CITY OF MILWAUKEE
DEPARTMENT OF PUBLIC WORKS
MILWAUKEE WATER WORKS

ADDENDUM NO. 1

The purpose of this addendum is to provide updated information to supersede and change the Contract Documents for HP-179.

Official Notice No. 56-2012
Location: Howard Avenue Water Purification Plant
HP-179: Administration Building HVAC & Lighting Replacement

**ADMINISTRATION BUILDING
SECOND FLOOR PLAN**
1/8" = 1' - 0"

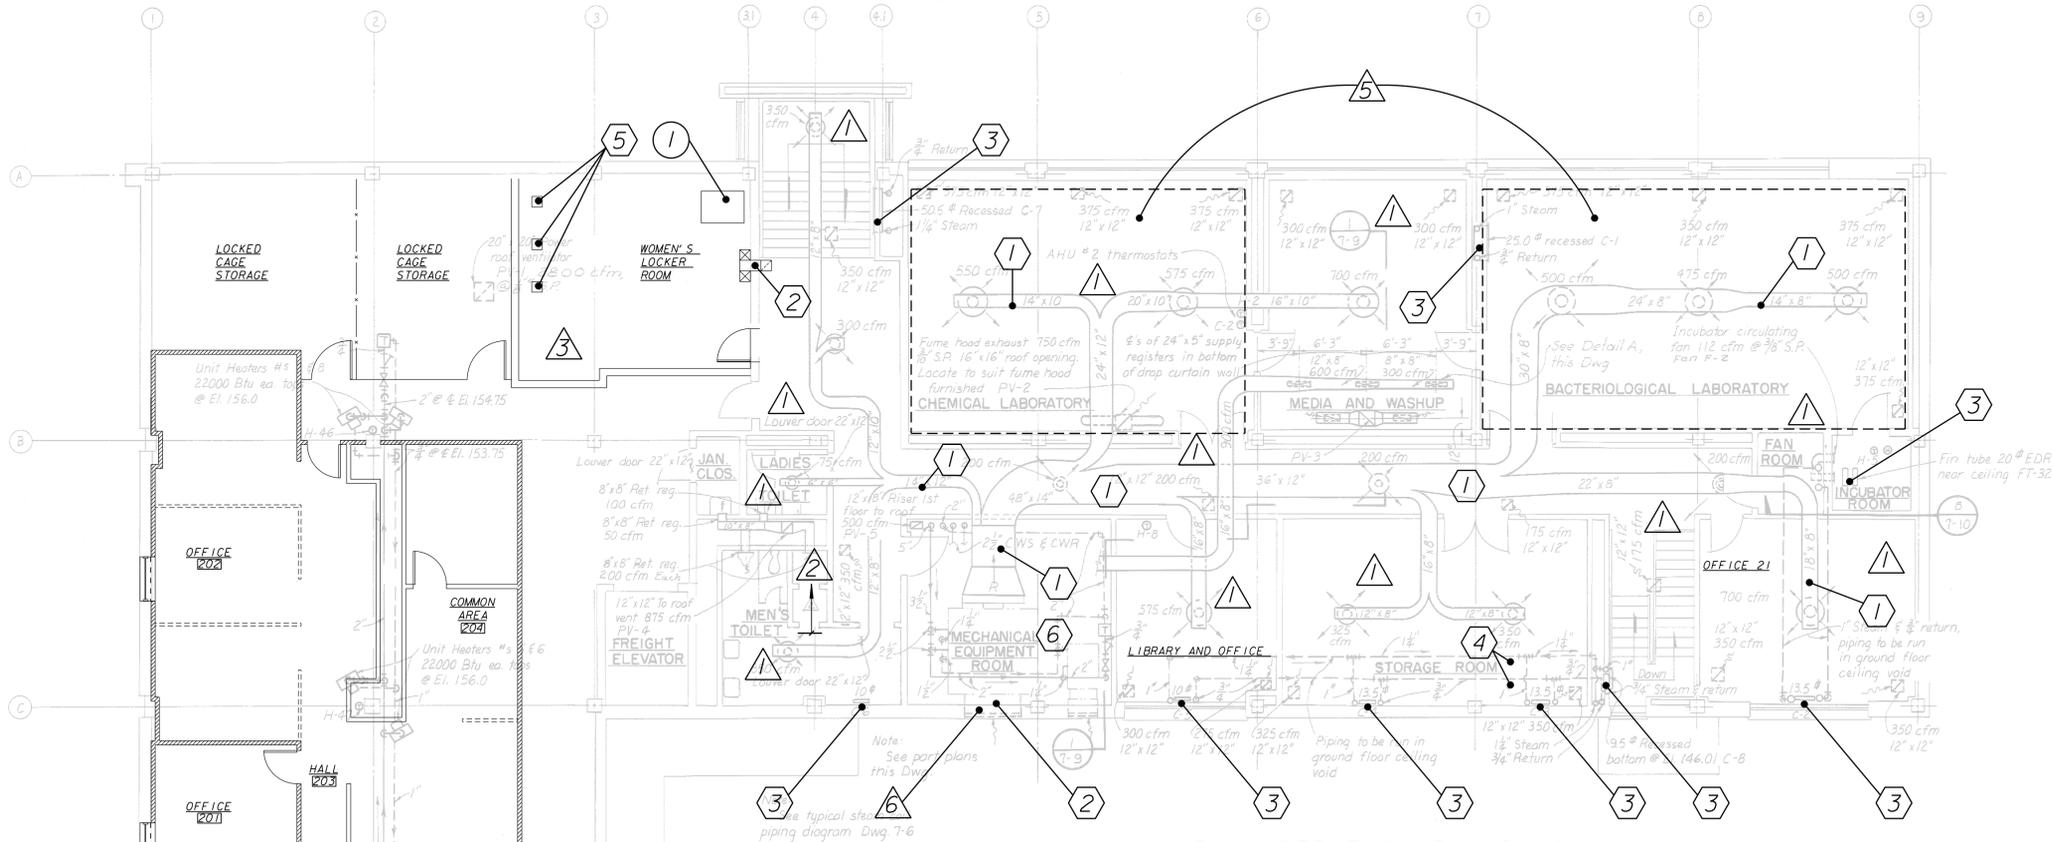
1. **HP-179-03, HP-179-04, and HP-179-05:**

REVISED Demolition Notes – Electrical #4 was deleted. Please see revised contract drawing.

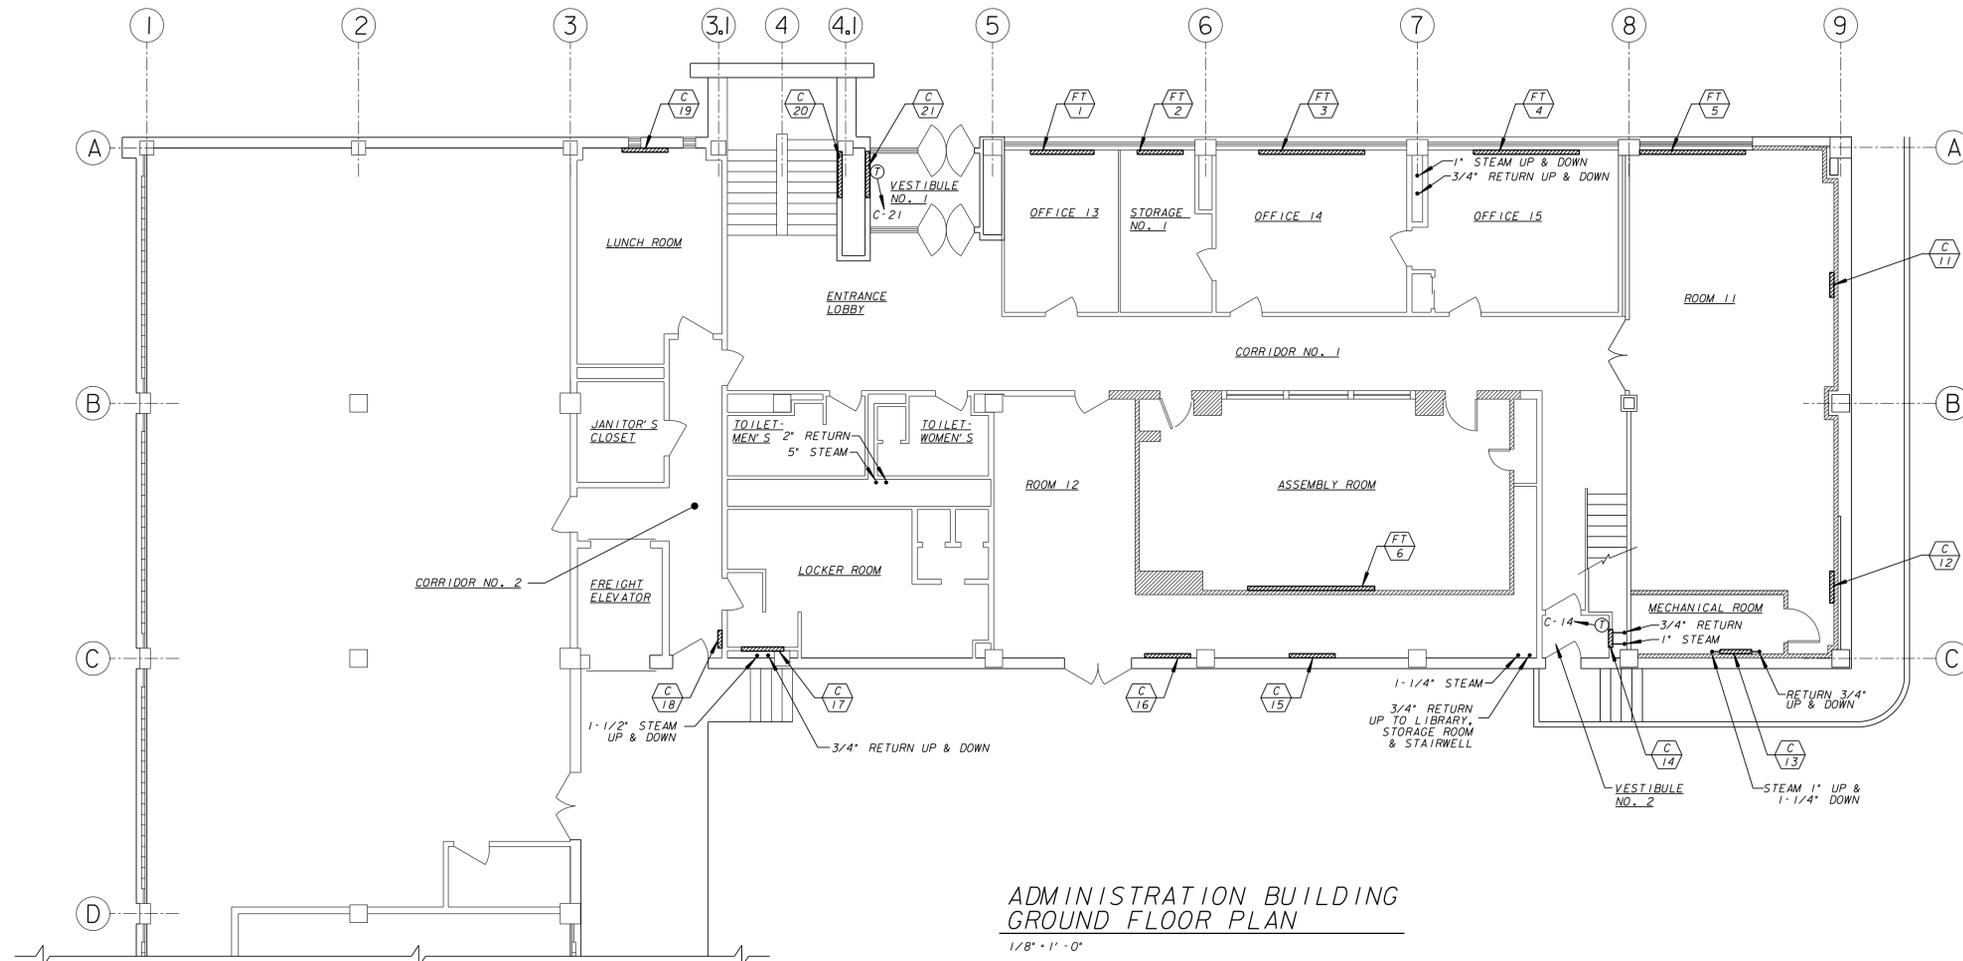
2. **HP-179-07 Ground Floor Plan – HVAC Piping:**

REVISED A shut-off valve was added to the Terminal Unit Detail. Please see revised contract drawing.

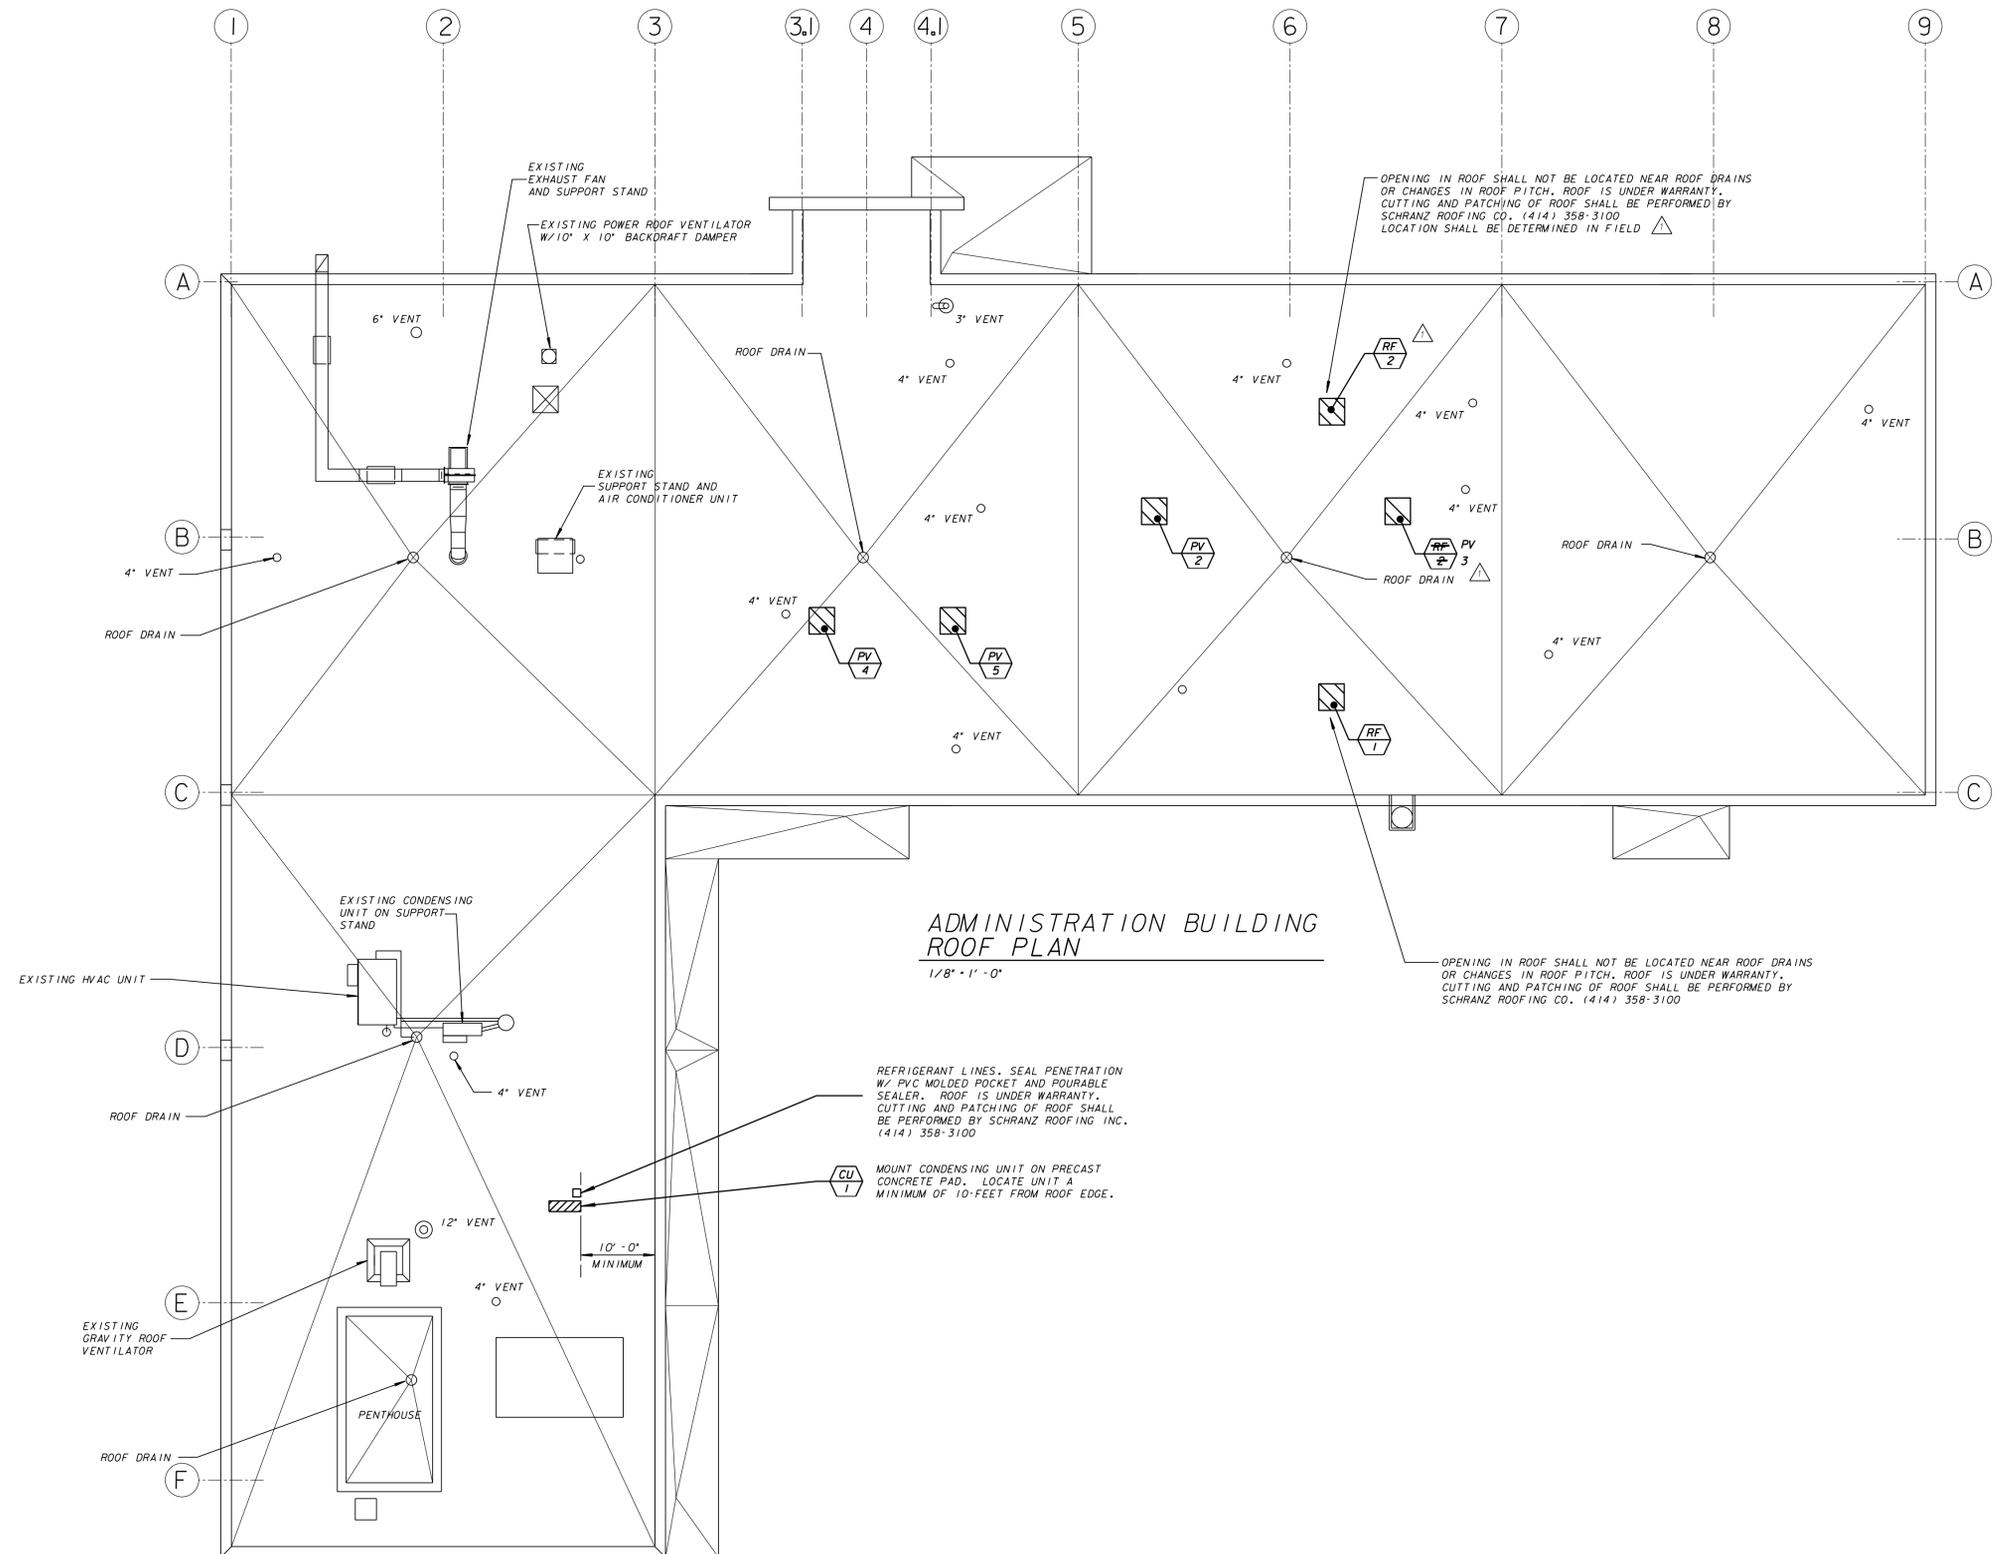
4. **HP-179-11 Roof Plan – HVAC:**

REVISED Roof mounted fan RF-2 was relocated from an existing opening in the roof to a roof location that will require a hole to be cut in the roof. A roof mounted fan PV-3 was added and shall be installed where RF-2 was originally located. Please see revised contract drawing.

DRAWING NO. **HP-179-16**

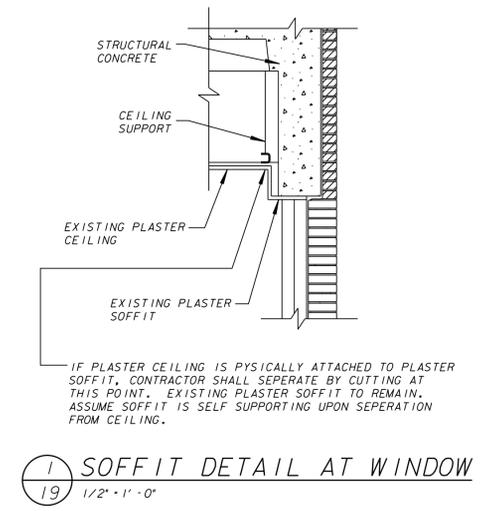
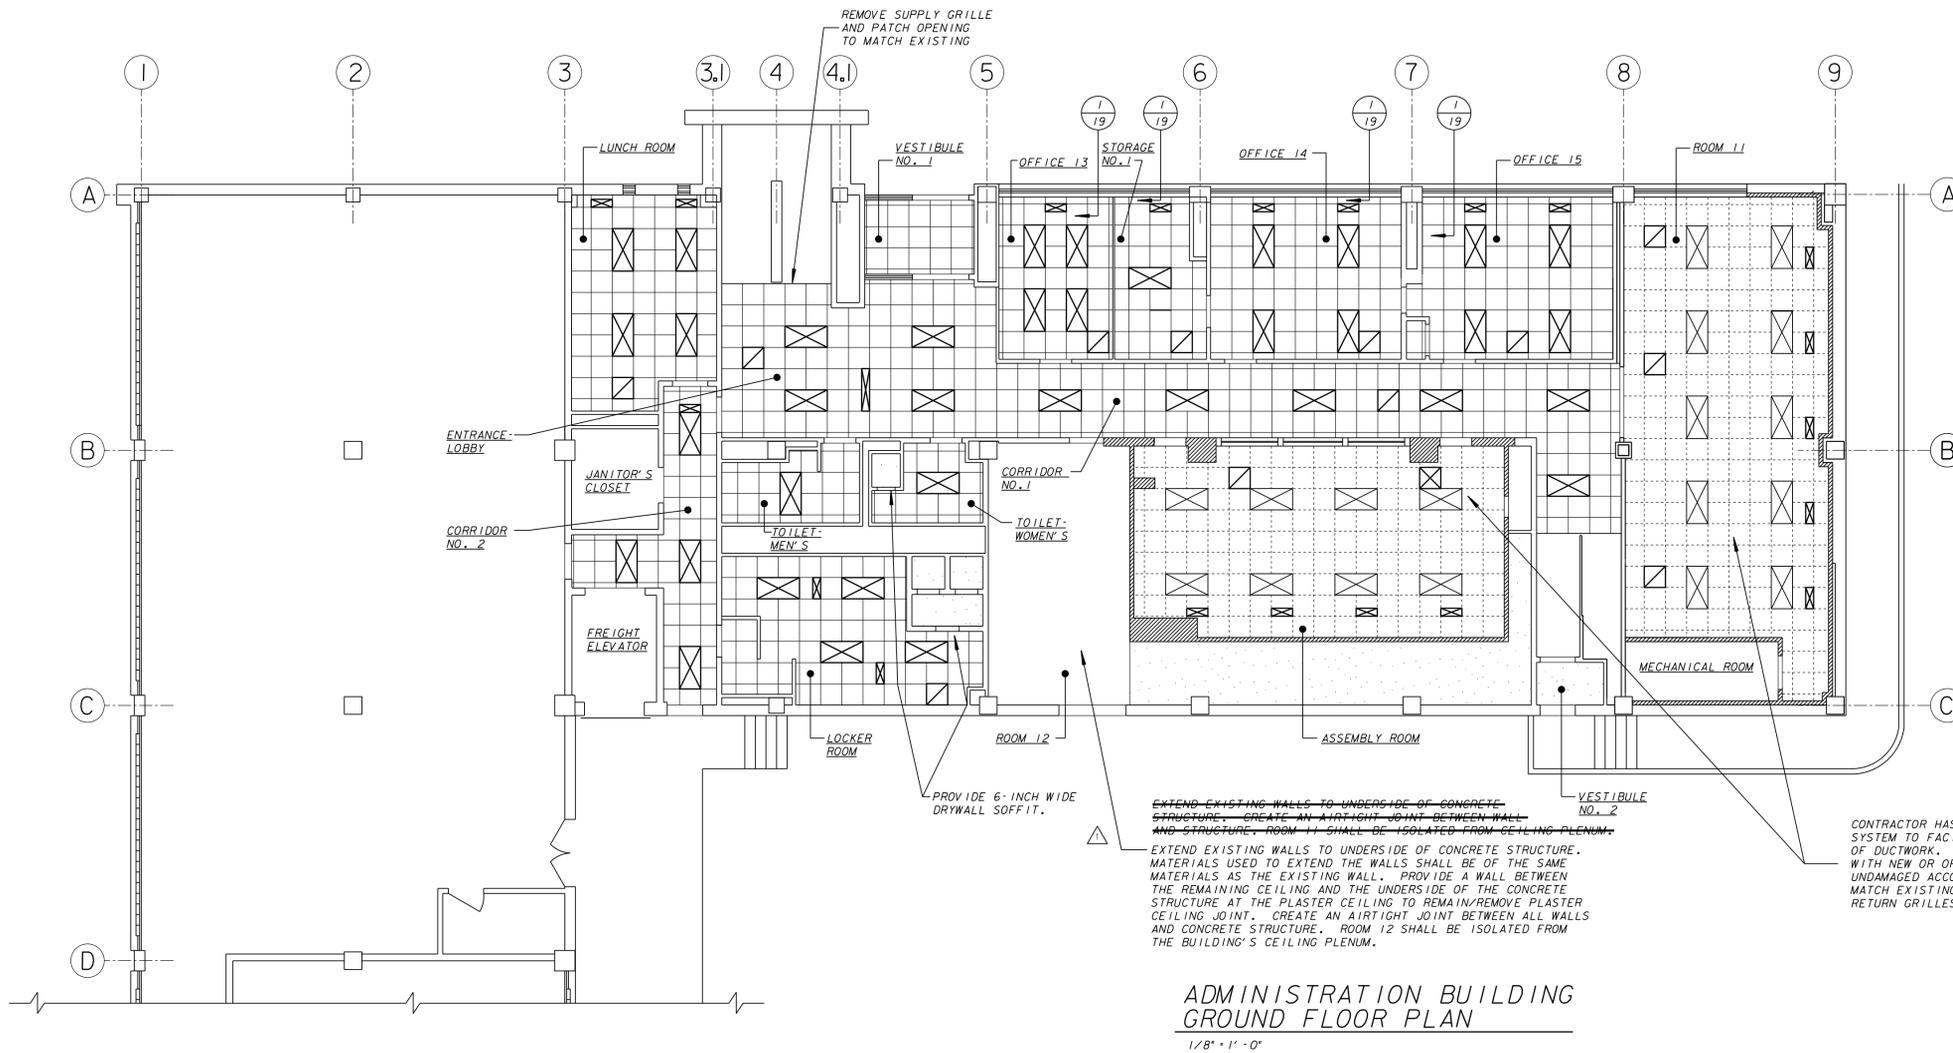
6. **HP-179-16 Ground Floor Architectural Ceiling Plan:**

REVISED “Legend” was modified: Title was changed and 2’ x 4’ Acoustic tile ceiling was changed to 2’ x 2’ Acoustic tile ceiling. Please see revised contract drawing.

REVISED Modified note concerning Room 12. Please see revised contract drawing.
